MEMORANDUM

To: Kathleen Smith, City of Haverhill
From: William G. Cunniff - Joslin, Lesser + Associates, Inc.
Date: February 16, 2016
Re: Construction Contingency Approval: Caleb Dustin Hunking School
Cc: James F. Scully; Jeffery Luxenberg; Adam Sniegocki

PROJECT#: 131411 - Hunking School

1 MAINTENANCE BUILDING - Option 2

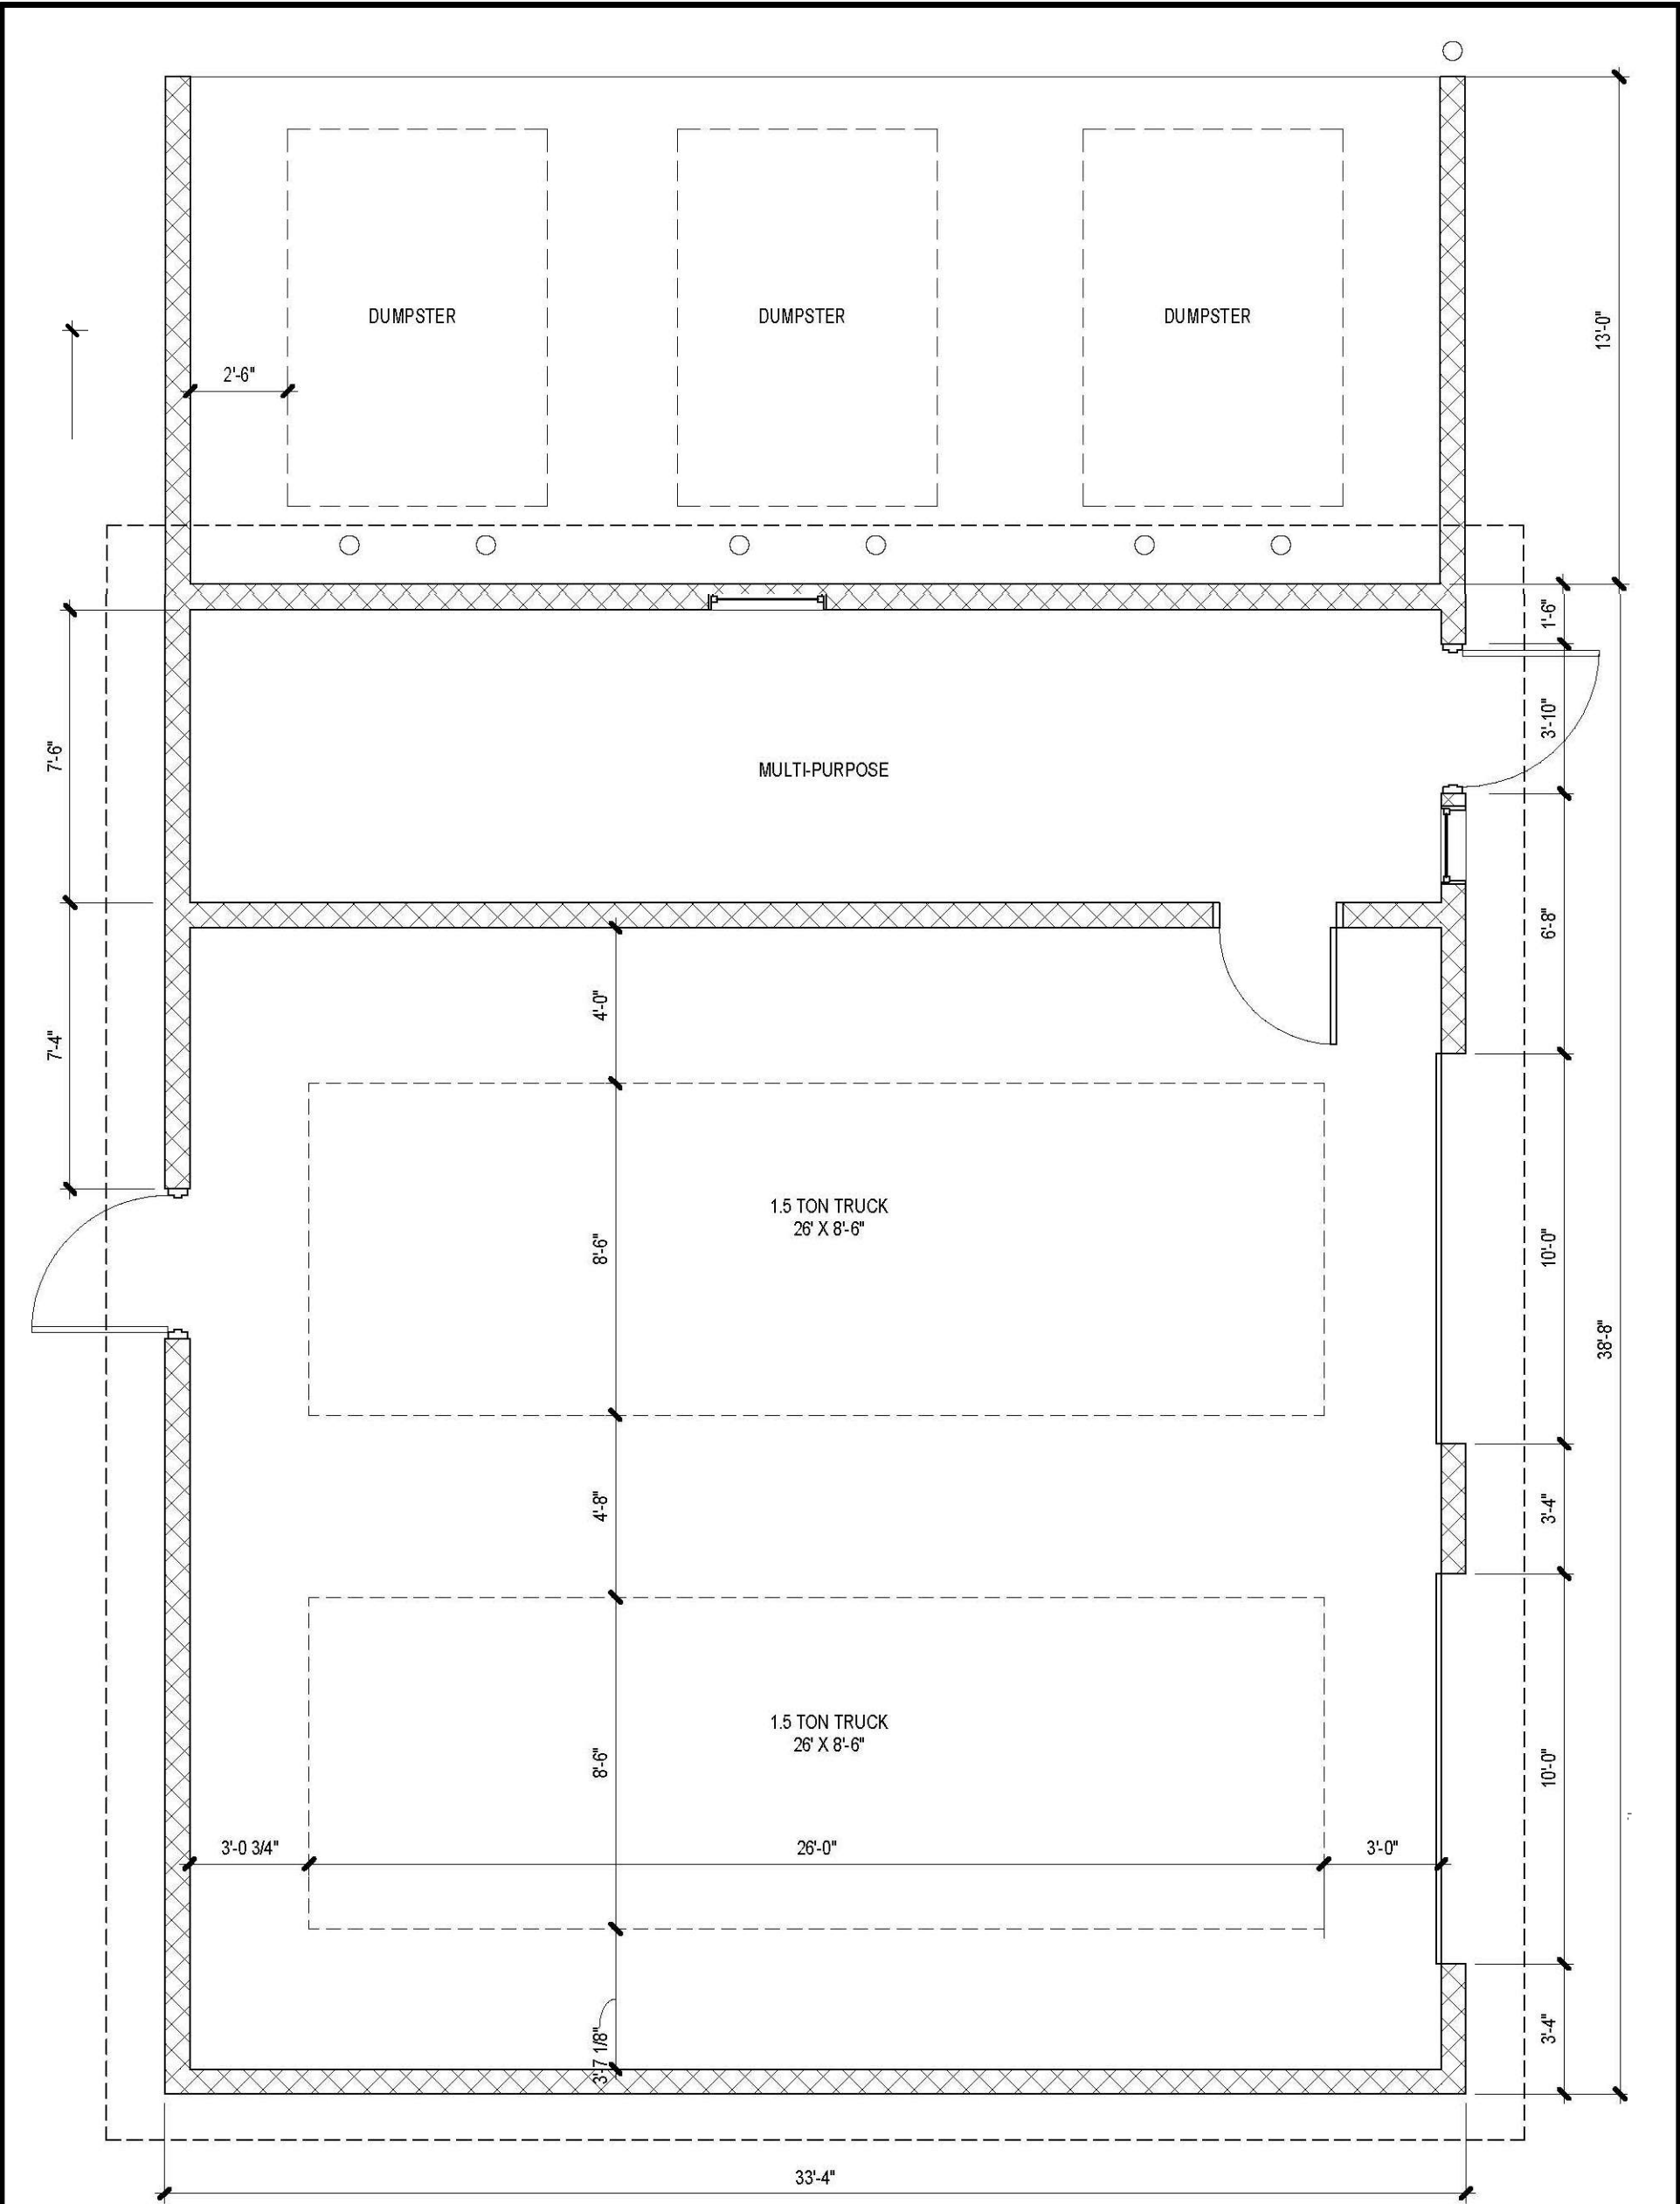
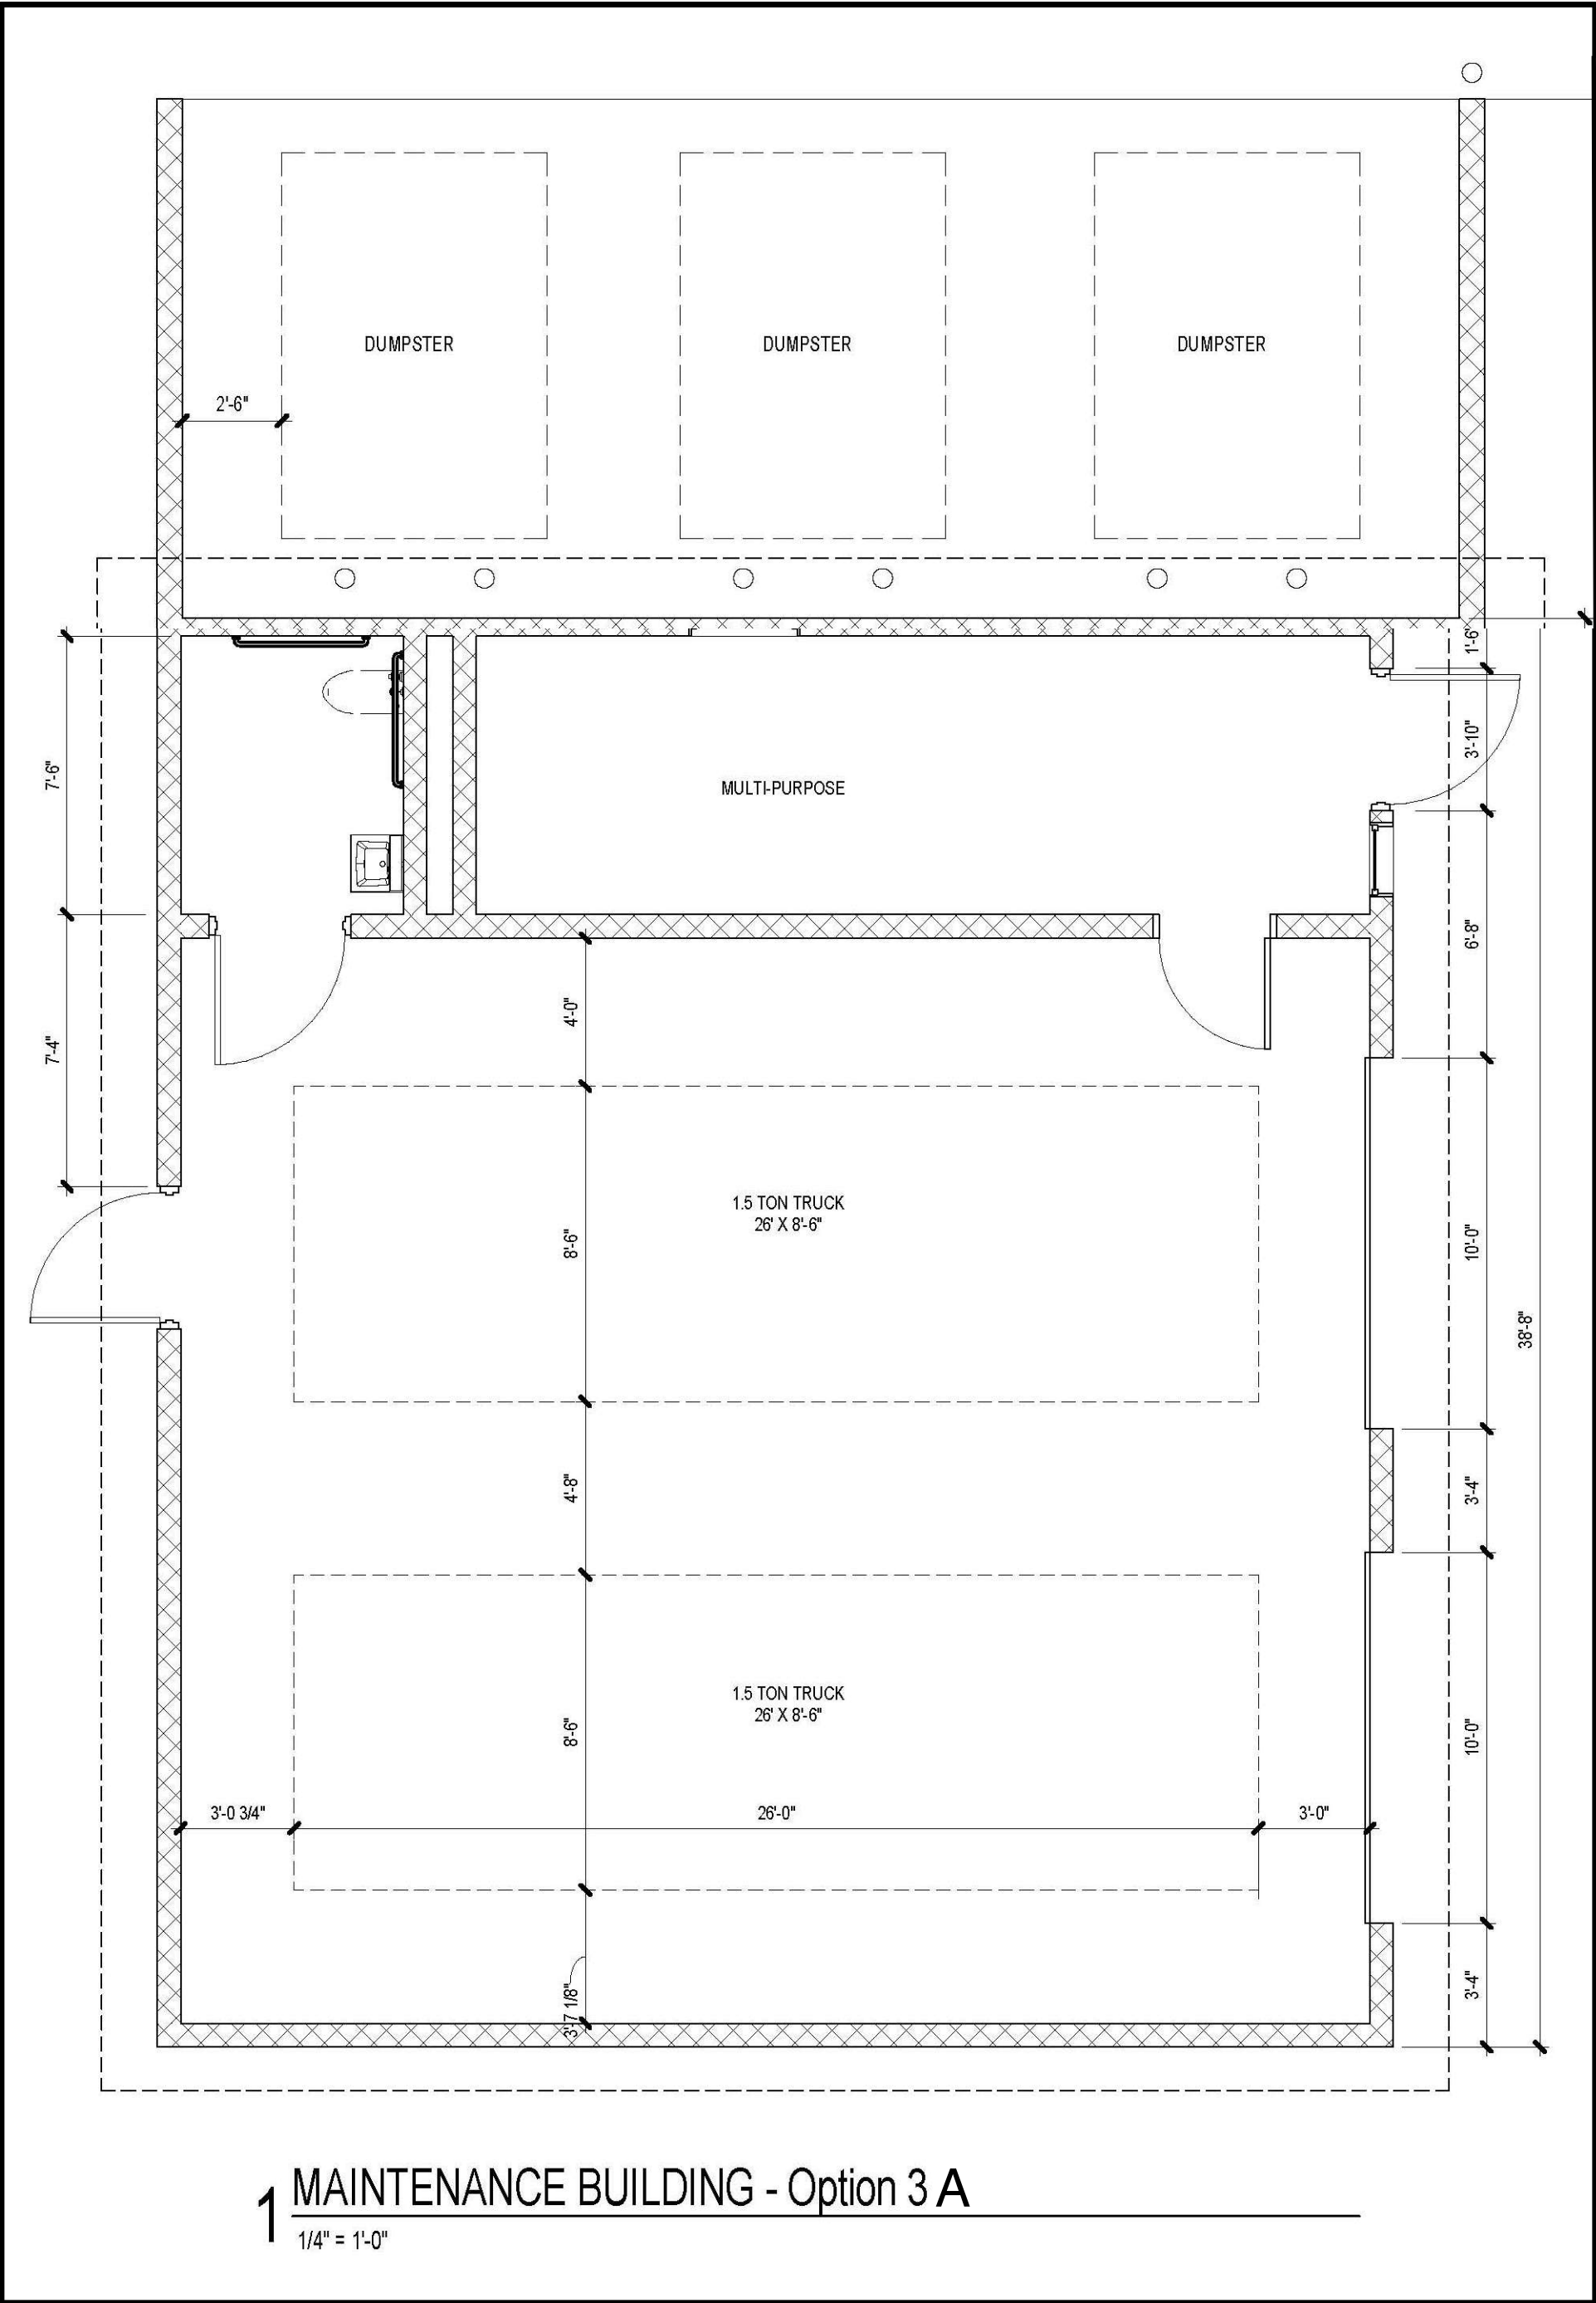
- Option #1 is the simplest of the options and the program includes only two garage bays. This option is approximately 1,015 GSF in size. Each of the two other options builds from that baseline.
- Option #2 adds approximately 270 GSF in the form of a separated room to serve multiple functions. 1,285 is the total approximate GSF

- Option #3 is also 1,285 GSF however; a portion of the multi-use room is dedicated to serve as a toilet room. We note that this configuration assumes that the District will receive a variance from Building Inspectional Services and the Plumbing Inspector in specific for construction of a single uni-sex toilet given the intended, occasional use by maintenance staff. We note the code would otherwise require a toilet for each gender. We further assume the toilet would not be available to the general public.

Preliminary Axonometric of the proposed Maintenance Building (Option 2 &3, Option 1 Similar)

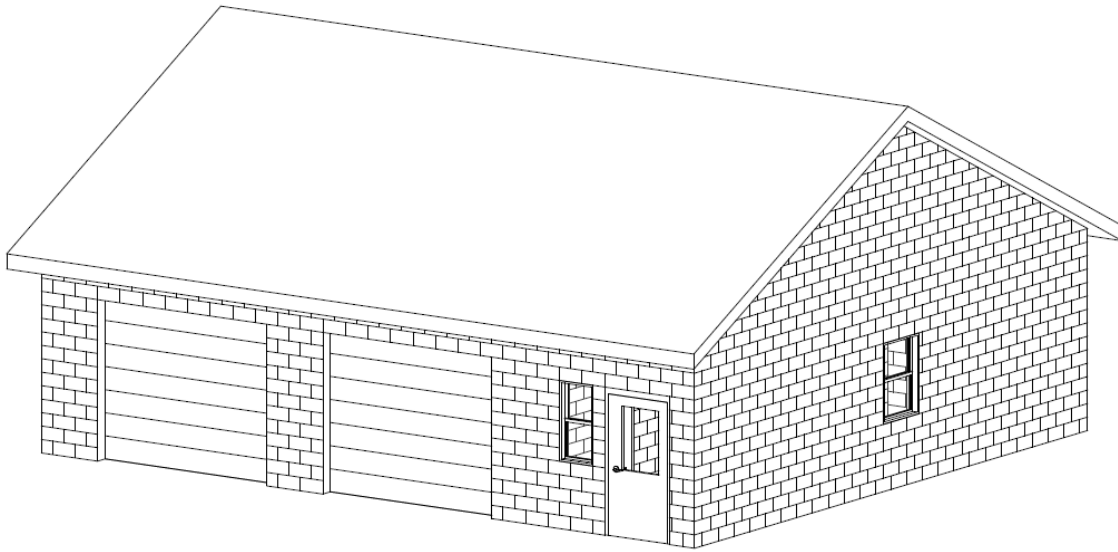
At the request of the Owner, JCJ has developed this preliminary Design Narrative for the addition of a maintenance building at the Caleb Dustin Hunking School project site. The intent of this document is to describe the Owner's program and the initial design intents for the purpose of developing an order of magnitude cost-estimate. Such an estimate is to be executed by the Owner's Construction Manager, Shawmut Design and Construction.

The Owner is presently considering three (3) possible configurations with the cost of each option a significant determiner as to which option they may elect to proceed with. The Owner's ideal program includes the following elements;
